# **Statement of Response to An Bord Pleanála's Opinion**

## **Proposed Student Accommodation at The Former Victor Motors Site, Goatstown Road, Dublin 14**

**John Spain Associates**

**March 2022**

**Figure 4 - Locations of internal student amenity space through out the development including central courtyard landscape proposal**

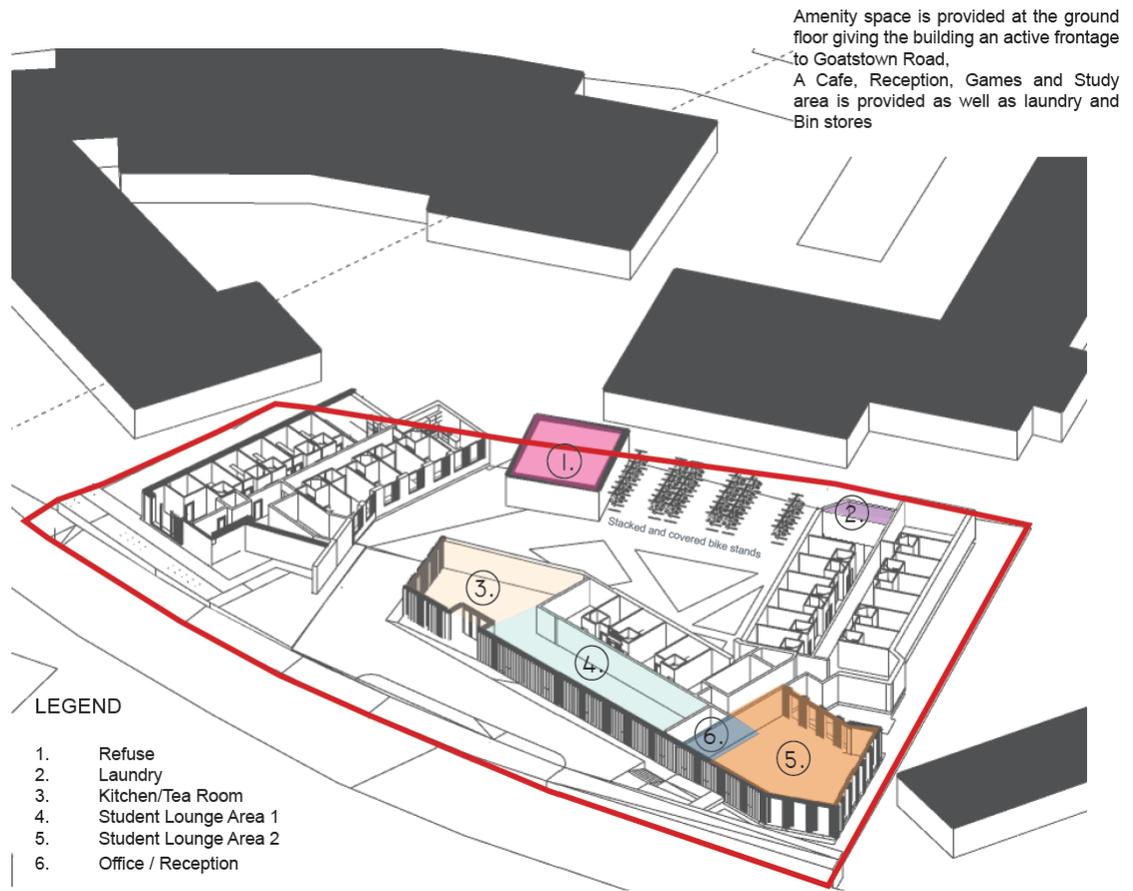
*Further consideration of, and if necessary, further justification for, the quantum and distribution of public open space provided to serve the development, also internal communal services and amenities for residents of the scheme, to address the following matters:*

- *Hard and soft landscaping and SUDS measures, including the detailed layout, accessibility and management of roof gardens (if provided);*
- *Potential integration of cycle parking and refuse storage into the ground floor of the development.*

2.27 **Response:** The following section is to be read in conjunction with the Housing Quality Assessment prepared by Reddy Architecture which provides a detailed breakdown including illustrative diagrams of the communal open space provision and allocated amenity space through out the site. A total of 2,025sqm of amenity space is provided throughout the site in the form of 1,516 sqm of external amenity space and 509 sqm of internal amenity space. This equates to c. 9sqm of amenity space per resident which is allocated through-out the scheme as shown below.

Figure 13 - View of the neighbourhood centre from Willowfield Park showing the scheme in the background

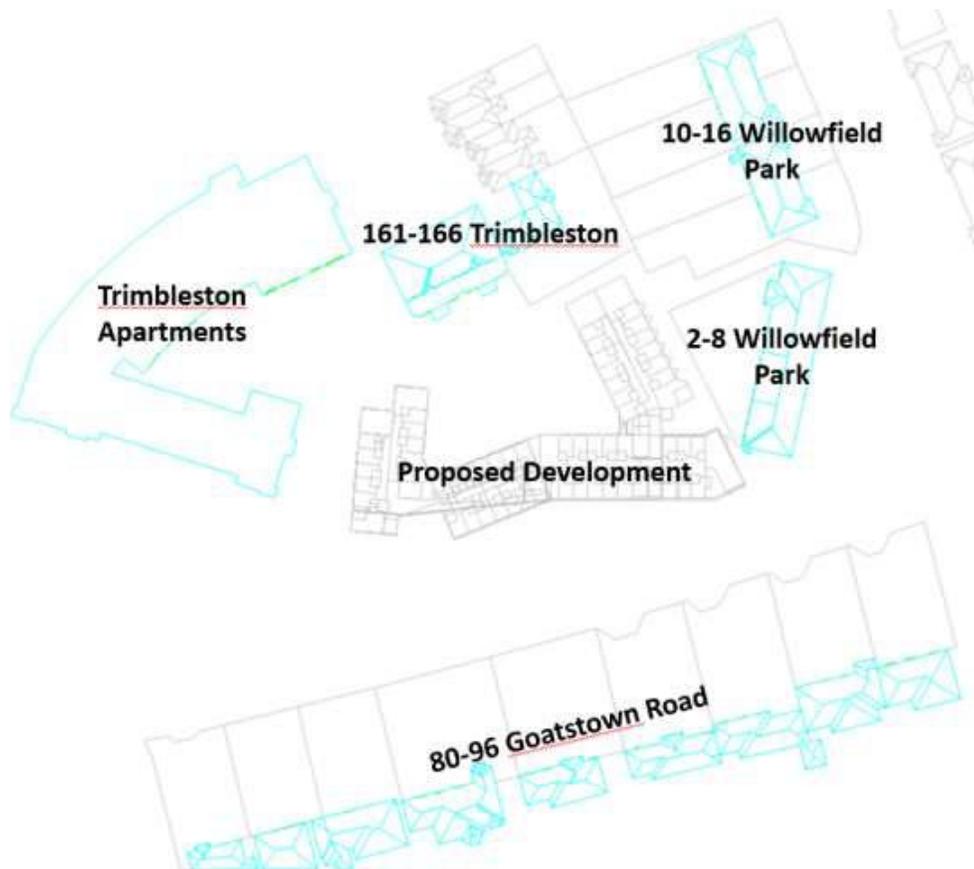
- *Visual Impact Assessment to include verified photomontages of the development from Goatstown Road (north and south of the site), from within the Trimbleston development and from Willowfield Park. The VIA should include views of the development with both winter and summer vegetation and to include any plant or other structures on the roof of the proposed development, in order to give as accurate a representation as possible.*

2.42 **Response:** A Townscape and Visual Impact Assessment has been prepared by Parkhood Landscape Architects and accompanies the application. Verified Views and photomontages from 14 locations including summer and winter time views have been prepared by 3D Design Bureau and accompany the application (see below). Extracts below show the views from Willowfield Park and Trimbleston respectively as required. The assessment states;

**Figure 15 - Nos. 161-166 Trimbleston (Source: Passive Dynamics)**

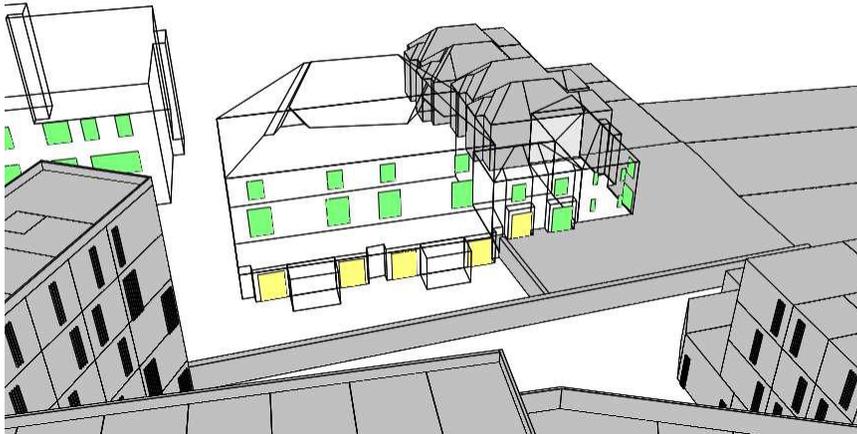
- *Assessment of overshadowing and impacts on natural daylight in adjacent habitable rooms, communal open spaces and private amenity areas having regard to BRE guidance.*

- 2.46 More specifically, in relation to surrounding adjacent duplexes at 161-166 Trimbleston the report found:

*“Windows shown in green have achieved a VSC of  $\geq 27\%$ . If the VSC is greater than 27% then enough skylight should be reaching the window of the existing buildings. The windows in yellow achieve a VSC of less than 27% but the new VSC is greater than or equal to 80% of its initial value pre-development in line with the recommendation of the BRE Guide. As shown, the openings of all properties assessed in 161 to 166 Trimbleston meet BRE recommended VSC targets.”*

Figure 19 - Proposed ground floor amenity spaces

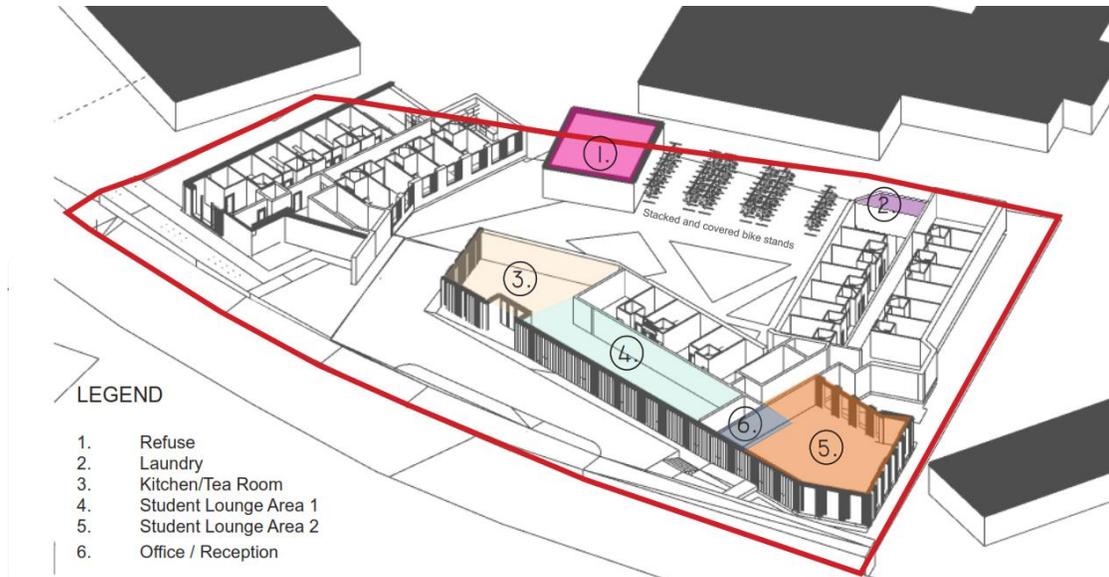
- *Provision of an active frontage to Goatstown Road at ground floor level, to include consideration of the location of the proposed concierge/reception area;*

2.50 **Response:** The concierge building has been positioned to front Goatstown Road. The ground floor of the building fronting Goatstown Road will accommodate the primary internal amenity space for resident use as shown at Figures 12 and 13 below. The spaces include floor to ceiling glazing fronting Goatstown Road. This will allow for direct interaction with the street. Direct sight lines and a physical connection is also provided from the street to the concierge office via pathway.

**Figure 21 - Section showing the site interface with Goatstown Road**

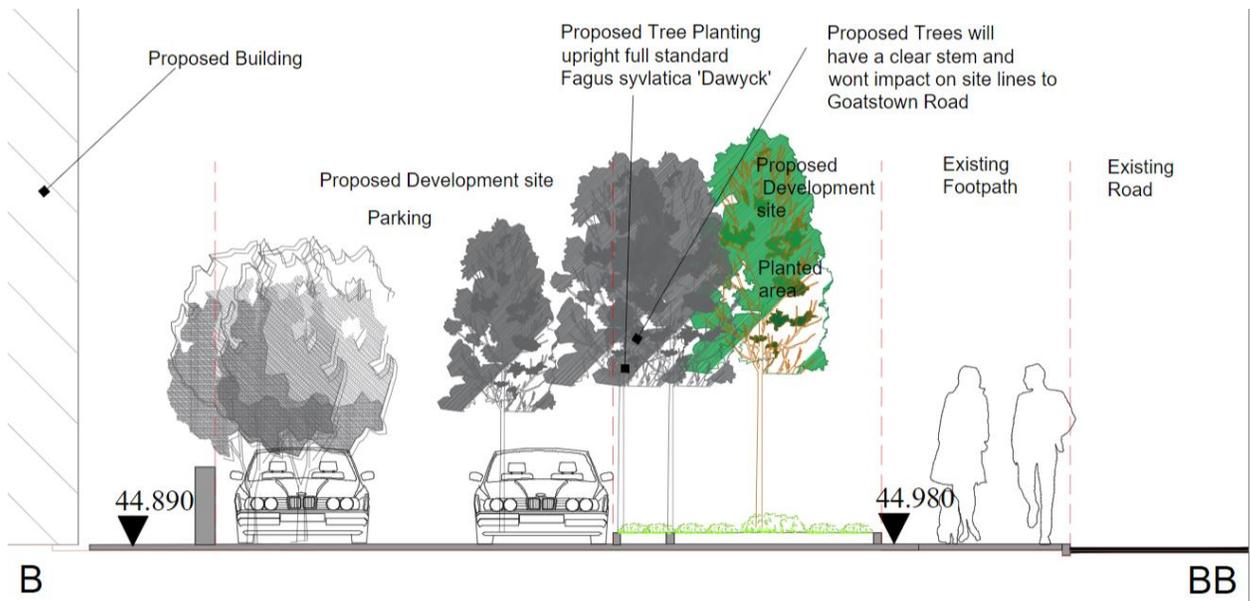
- *Provision of a positive contribution to the public realm at Goatstown Road, to include boundary treatment, pedestrian and cycle facilities and hard and soft landscaping.*

2.52 **Response: Details of the proposed landscape response is included in the Design Rationale** and accompanying plans prepared by Ronan MacDiarmada Landscape Architects. A low wall is proposed (600mm) to match Trimbleston to the north. This will include a railing adjacent to the bike stands to ensure security of the bikes. Access to visit cycle spaces will be via coded gate entry, again to secure the bikes. As the site curves to the south, planting islands are proposed along the frontage as shown at Figure 20, providing pedestrian permeability through the frontage of the site and providing seamless integration with the public domain. Pedestrian permeability is the focus and centrepiece of the landscape proposal at the street interface.

**Figure 23 - Proposed finish**

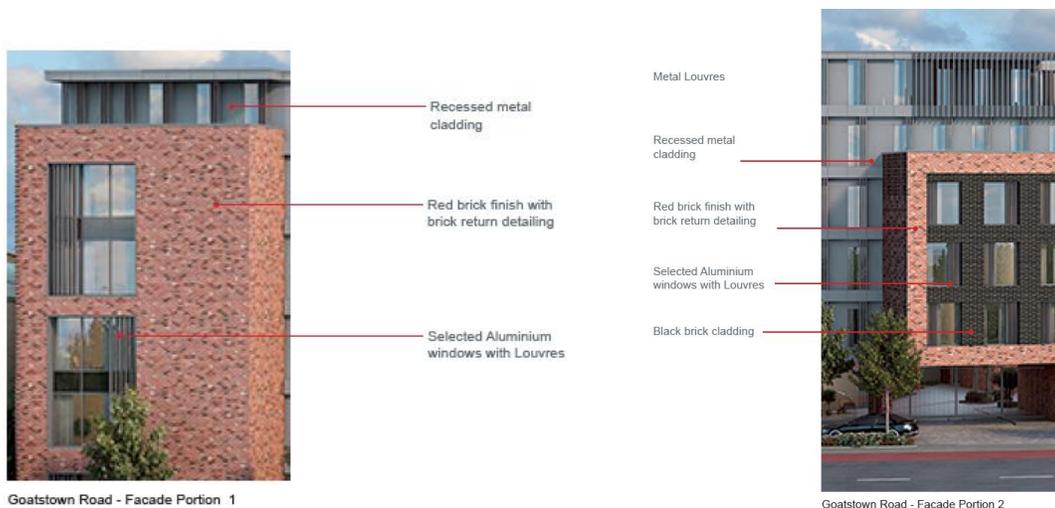
**Particular regard should be had to the requirement to provide high quality and sustainable finishes and details which seek to create a distinctive character for**

**the development. The report should also demonstrate that the development provides the optimal architectural solution and sustainable development of the site and in this regard, the proposed development shall be accompanied by an architectural report and accompanying drawings which outlines the design rationale for the proposed height and design strategy having regard to inter alia, national and local planning policy, the site's context and locational attributes.**

- 3.13 A Landscape Rationale has been prepared by Ronan MacDiarmada and Associates and details the specific finishes and materials to be used throughout the proposed landscape scheme for the site. In addition, detailed sections have also been prepared by the landscape architects and illustrate the proposed boundary interface with the public realm.
- 3.14 In relation to the building itself, detailed finishes and material selections have been included within Section 4 of the accompanying Architectural Response Report prepared by Reddy Architecture. These include;
- Brick finish with brick return detailing
  - Recessed metal cladding / brick / rendered panels
  - Protruding bay windows
  - Glazed Curtain Walling with a selected Aluminum Windows /Doors
